MEETING NOTES

Meeting Date: Friday, July 7th, 2017 – 11am-12pm
DFD Project Number: 14I2O
Project: Wittich Hall Renovation
Location: Wisconsin Historical Society – 816 State Street, Madison, WI 53706
Purpose: Wittich Hall – Historical Review Meeting
Prepared by: Michael Eberle, AIA

The purpose of this meeting was to review proposals for new interior guard/hand rails at floor openings and stairs, existing doors at entry zones, and proposed interior finish palette / pattern language.

HANDRAILS / GUARDRAILS

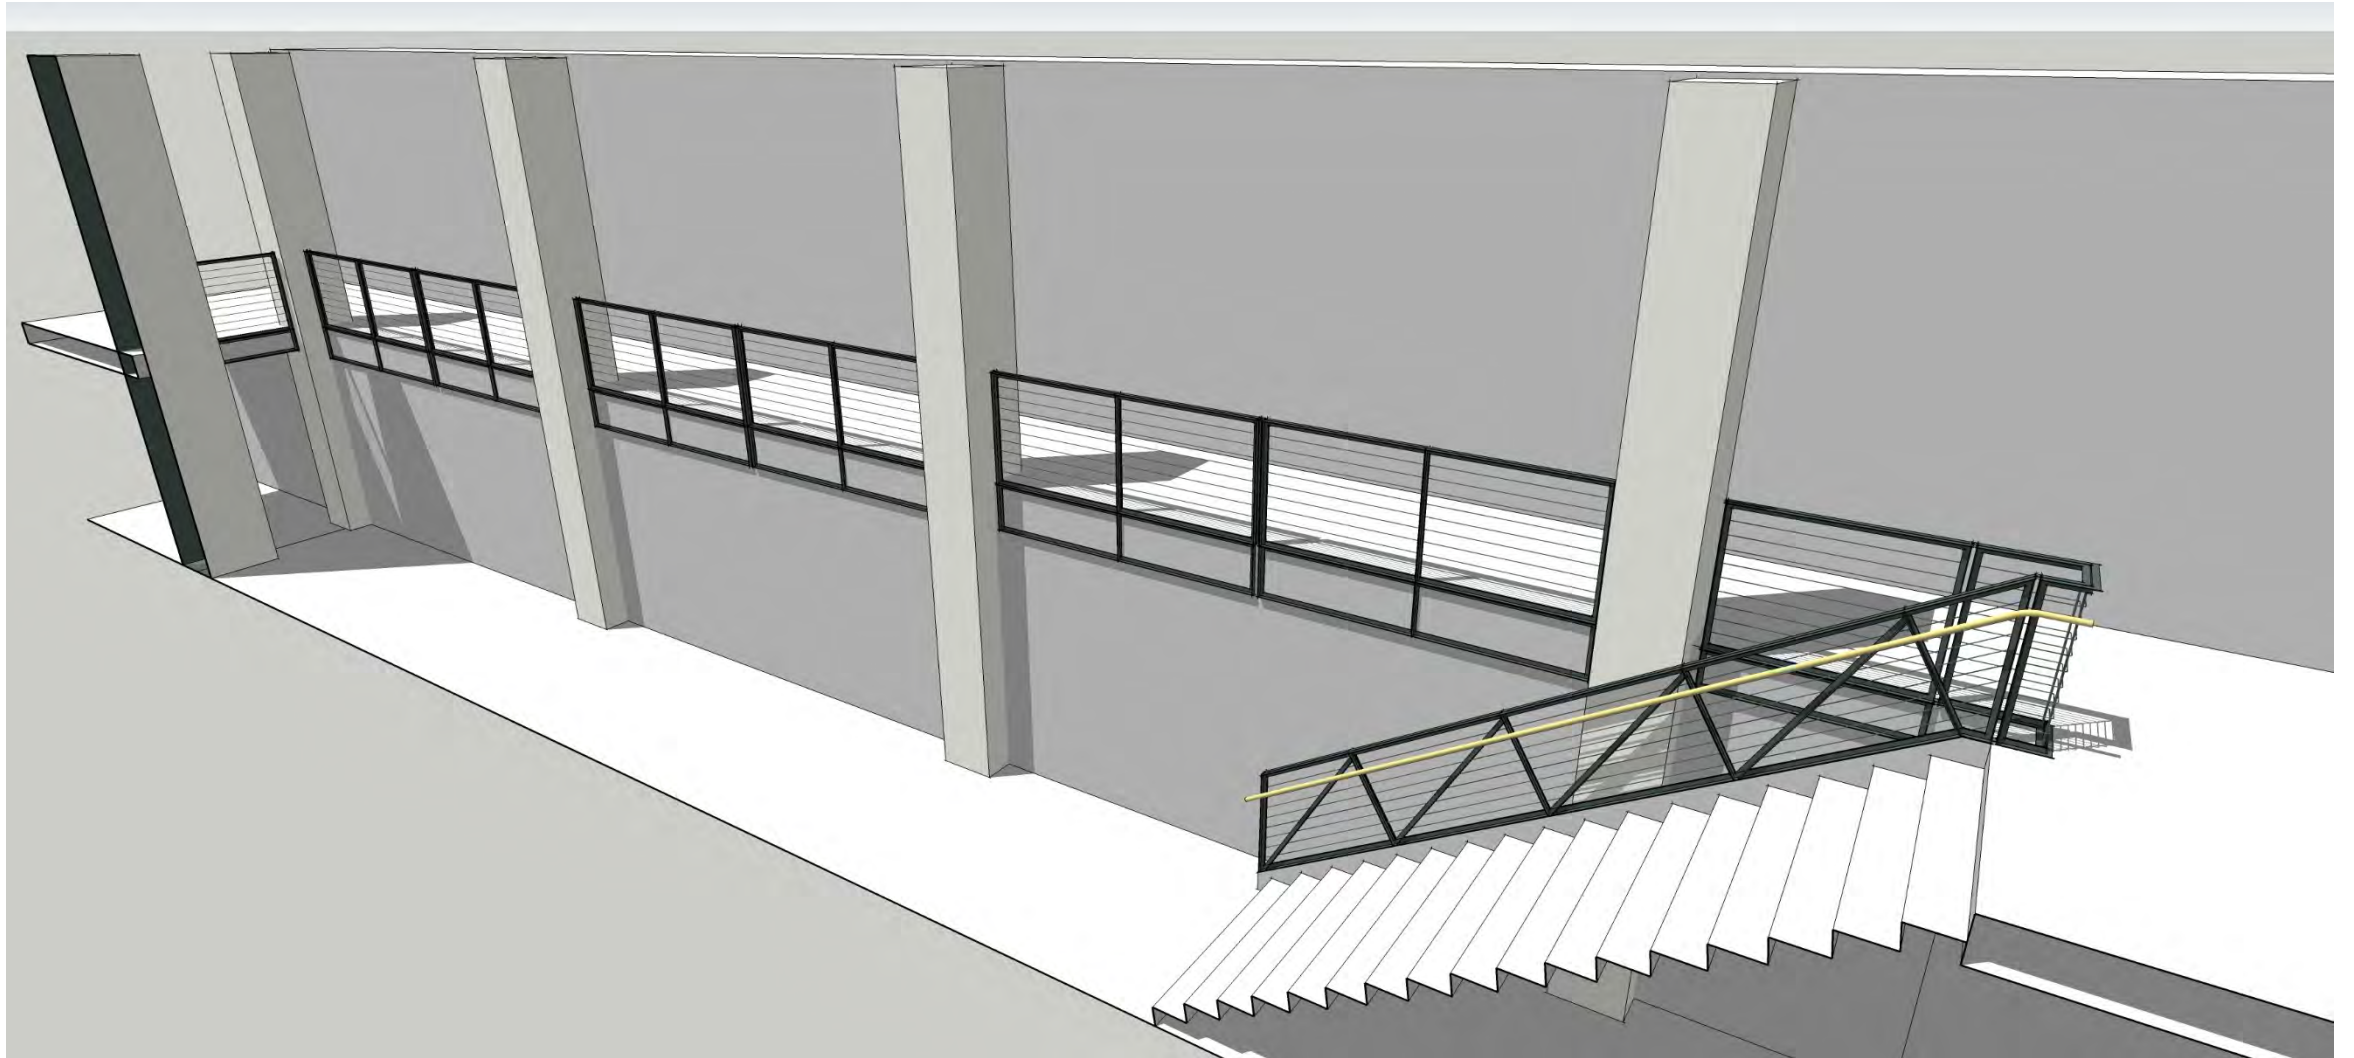
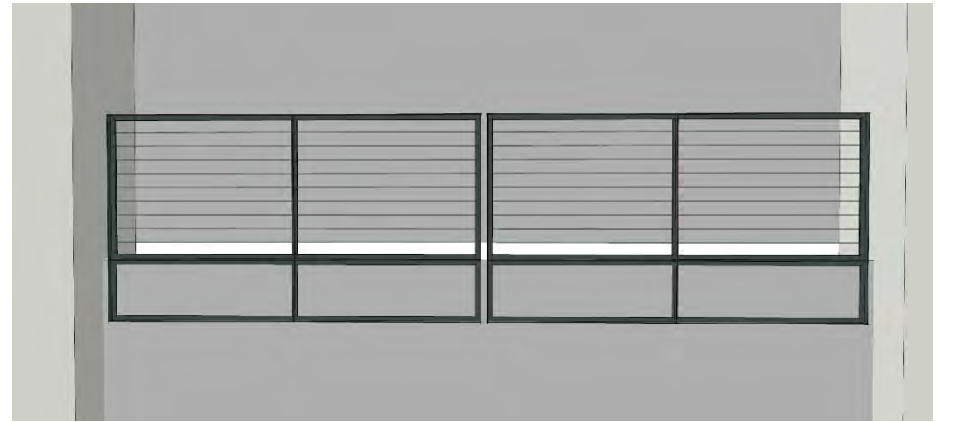
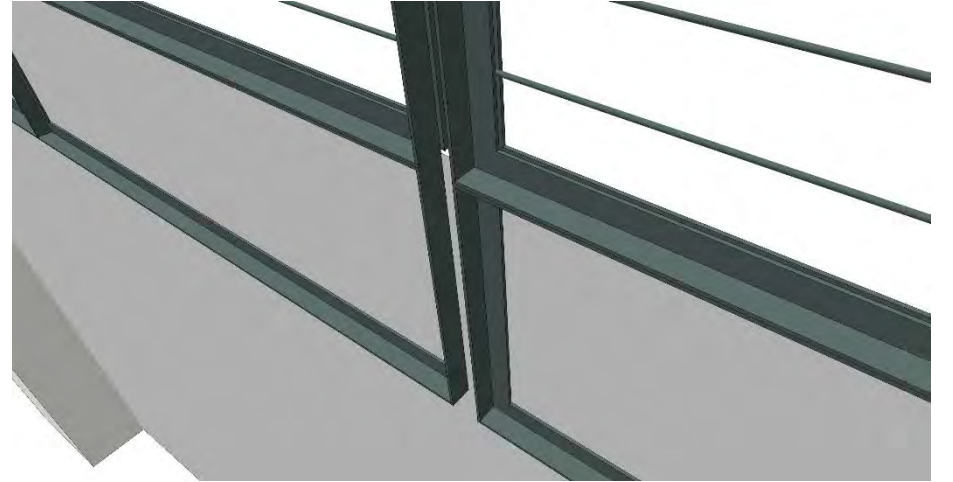
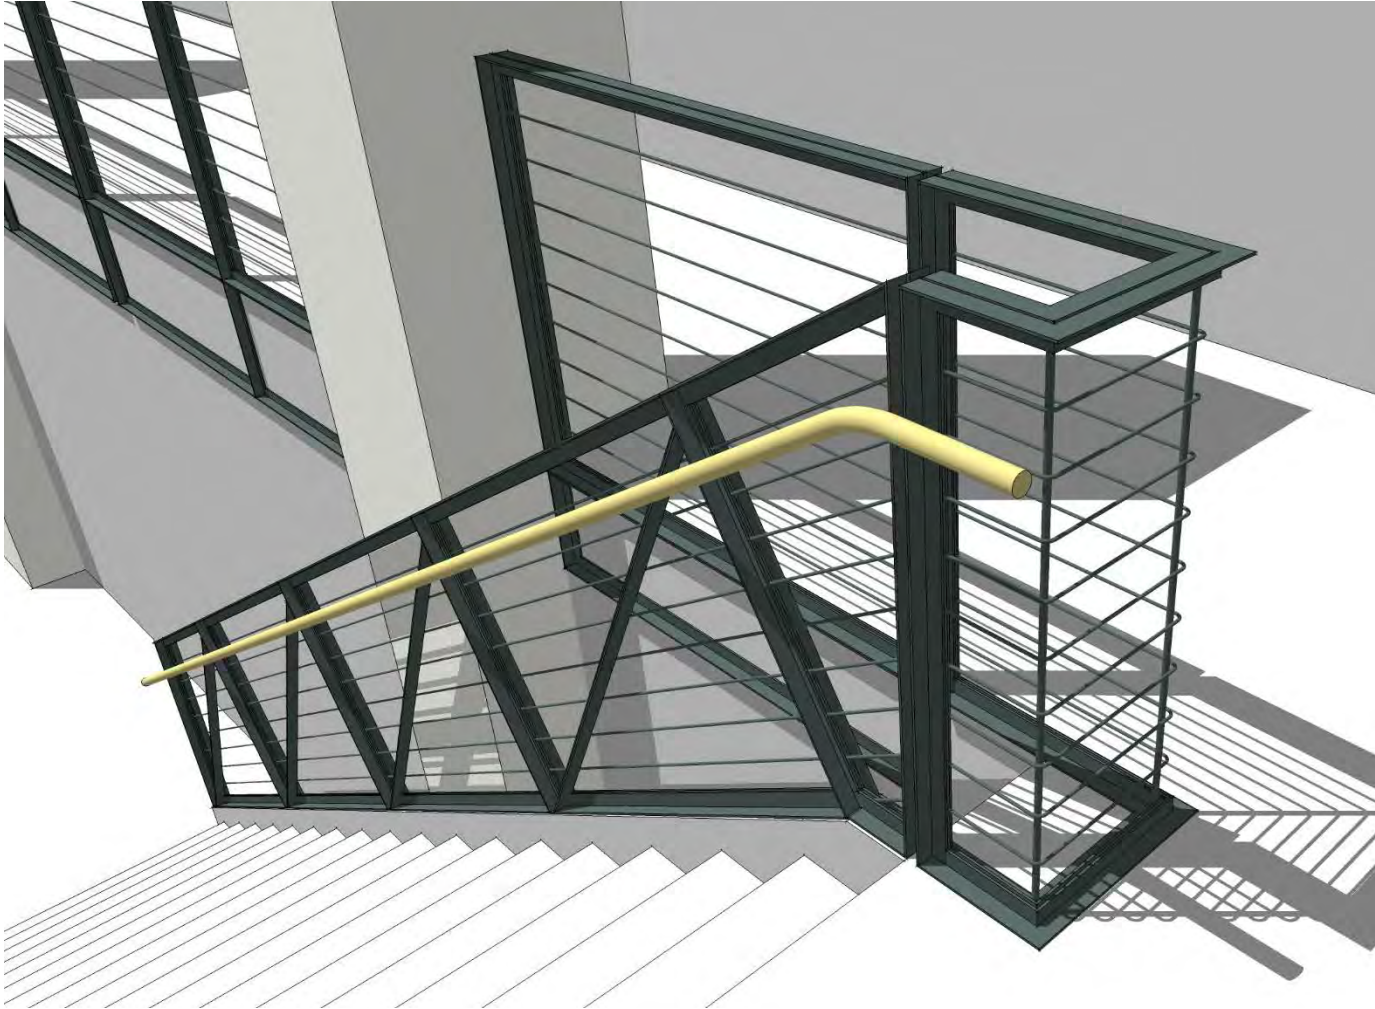
1. Doug presented a new design option for the railings. He reviewed the motif for all the guard / hand railings as being reflective of the exposed existing roof trusses within the building.
 - a. The railing design is a simplified version of the trusses.
 - b. Steel angles are reminiscent of truss construction.
 - c. Horizontal members will be 1/4" or 3/8" diameter steel rods.
 - d. All steel will be powder coated per the request from UW La Crosse.
 - e. The presented concept was acceptable.

FIRST FLOOR DOORS

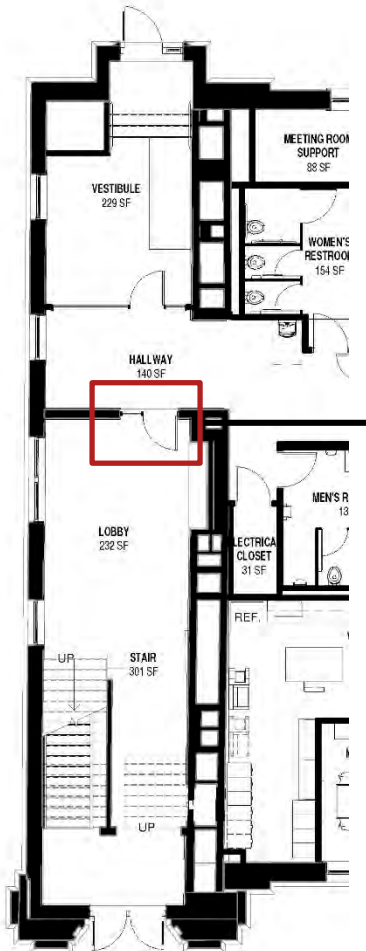
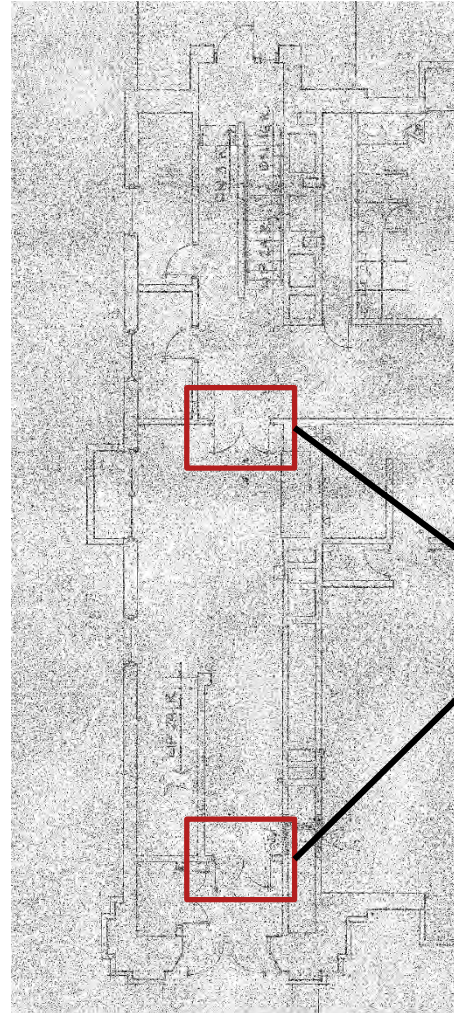
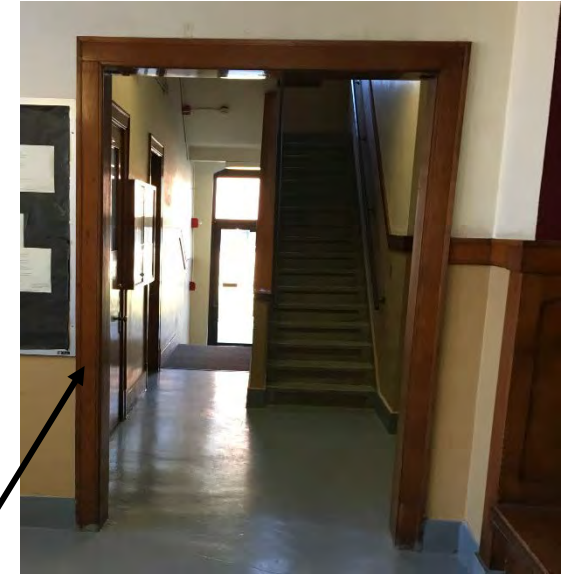
New code required 2 hour rated door

Doors no longer exist

1. 1916 – 1st Floor North Entry Zone Doors
 - a. Existing door in the north-south partition at the west entry was discussed.
 - i. The door needs to be removed and a new 90-minute door installed per code requirements.
 - ii. Jen requested that the existing opening and casing be kept at this location.
 - iii. A new fire rated door and sidelight will fill the existing cased opening.
 - iv. Jen requested that any of the new doors on the project not be faux wood grain. We confirmed that we will not have any of this in the project.

- b. New east entry partition
 - i. The new glass door and glass partition proposed creating a new vestibule was acceptable.
 - c. Single door into the SBDC workroom was requested to be kept, but could receive drywall or plaster partition on the workroom side.

FIRST FLOOR DOORS

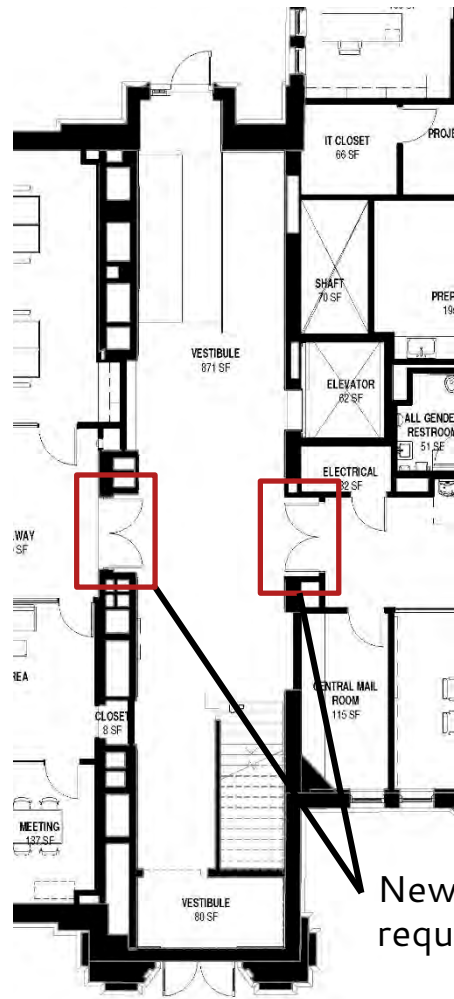
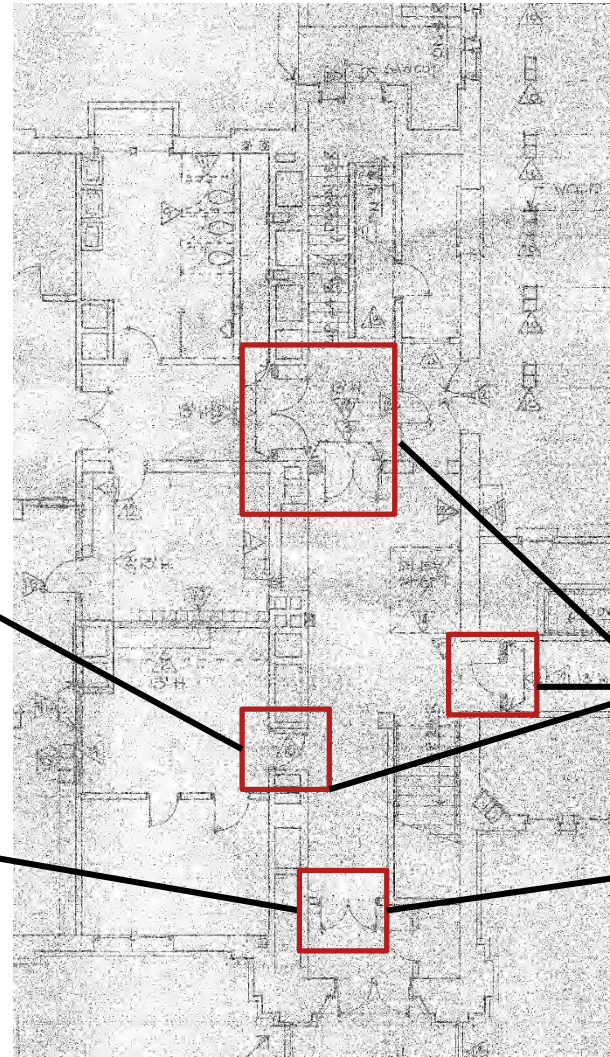
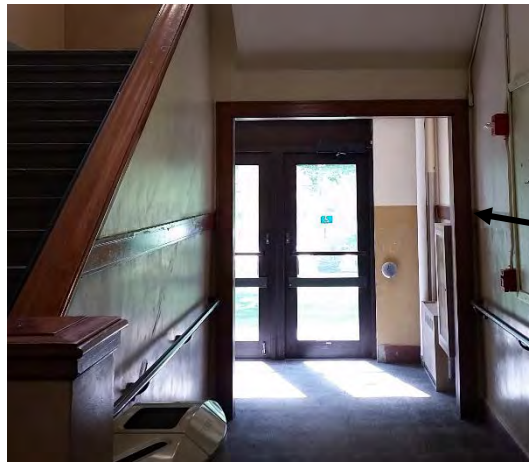
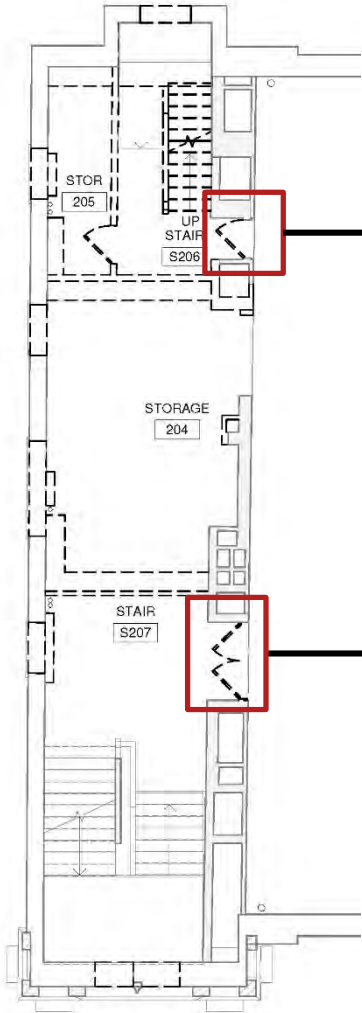
New code required doors

Doors removed during 1978 ADA remodel

Doors no longer exist

2. 1916 – 1st Floor South Entry Zone Doors
- a. The presented option showing the existing framed opening with the existing doors that were previously removed was acceptable.

- b. New pair of doors from the South Entry Zone into each wing was ok as discussed.
3. 1916 – 2nd Floor
- a. Ok to move existing pair of original doors (and opening trim) from the South Zone to the North Zone to replace the current non-historic hollow metal frame and wood door that was in the 1970 elevator project. Existing pair of doors is required to be replaced with 90-minute doors per code.

SECOND FLOOR DOORS

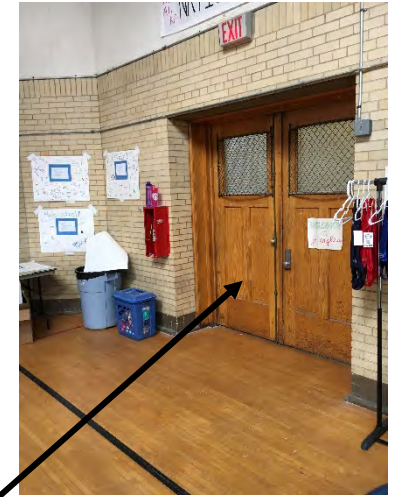
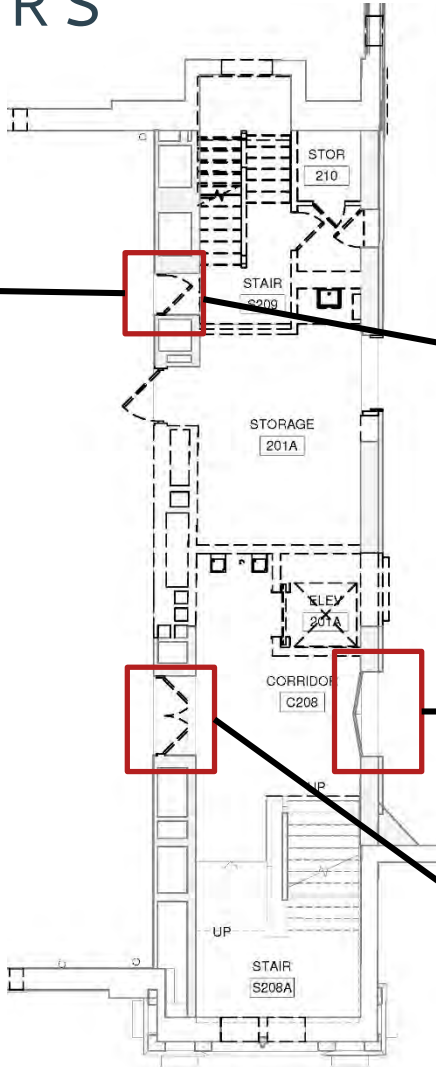
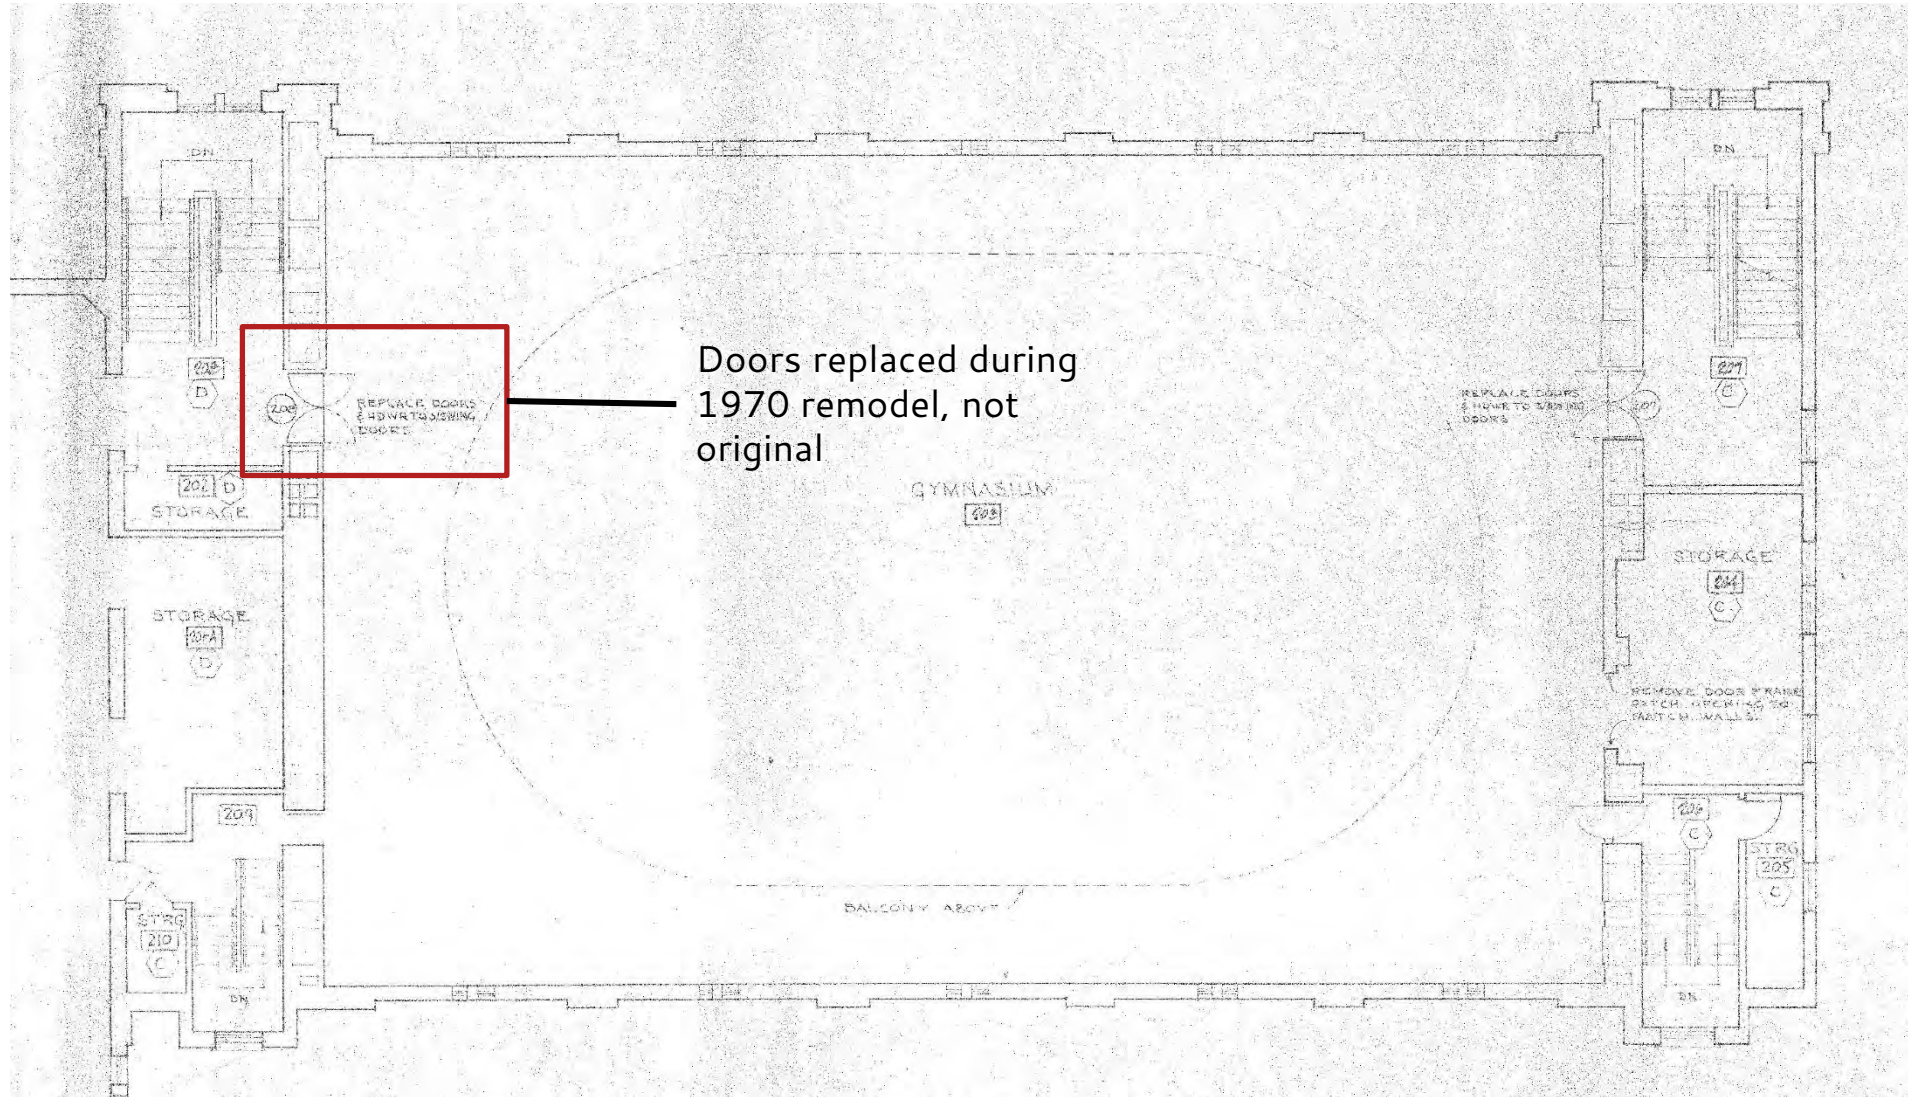
Existing original doors, do they need to be kept?

Doors must be replaced with code required 2 hour rated doors

Original Doors to remain, pinned in place

Doors replaced during 1970 remodel, not original

- b. Keeping the existing historic single leaf doors on the east side in 2 locations (on 2nd floor and 1st floor?) was acceptable.
 - c. Additional discussion is required to confirm the enclosure requirements for the open stair in the South Entry Zone.
